HARD TURNING

<u>AMENDMENT</u>

In response to the Office action of June 16, 2004, please amend the above-identified application as follows:

Amendments to the Drawings begin on page 10 of this paper and include both an attached replacement sheet and an annotated sheet showing changes.

Appl. No. 10/018,076
Amdt. Dated August 26, 2004
Reply to Office Action of June 16, 2004
Annotated Sheet Showing Changes
1 of 1

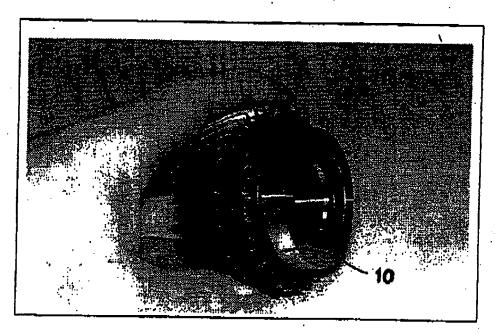
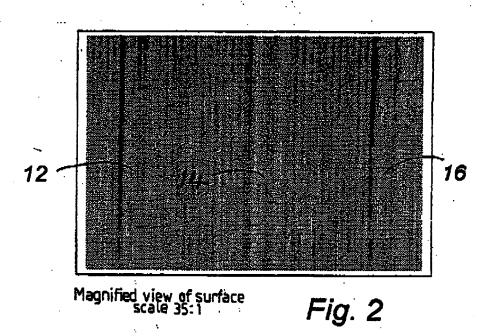
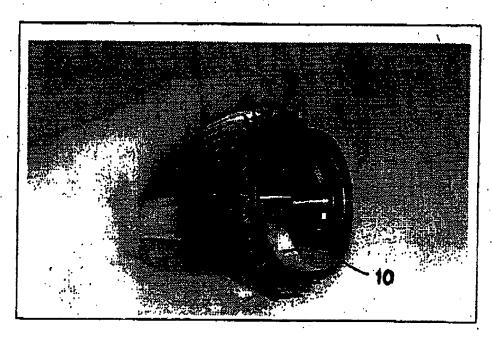
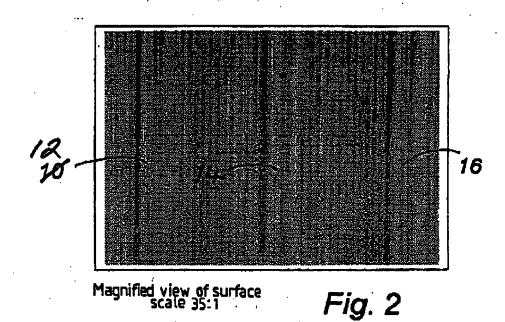
Included herewith for the Examiner's approval is an Annotated Sheet showing changes to the drawings and a Replacement Sheet of Drawings. In Figure 2, reference numeral 10 should be reference number 12 to correspond with the description of the invention at page 10, lines 17-19.

This amendment revises the drawings to correct an error in Figure 2.
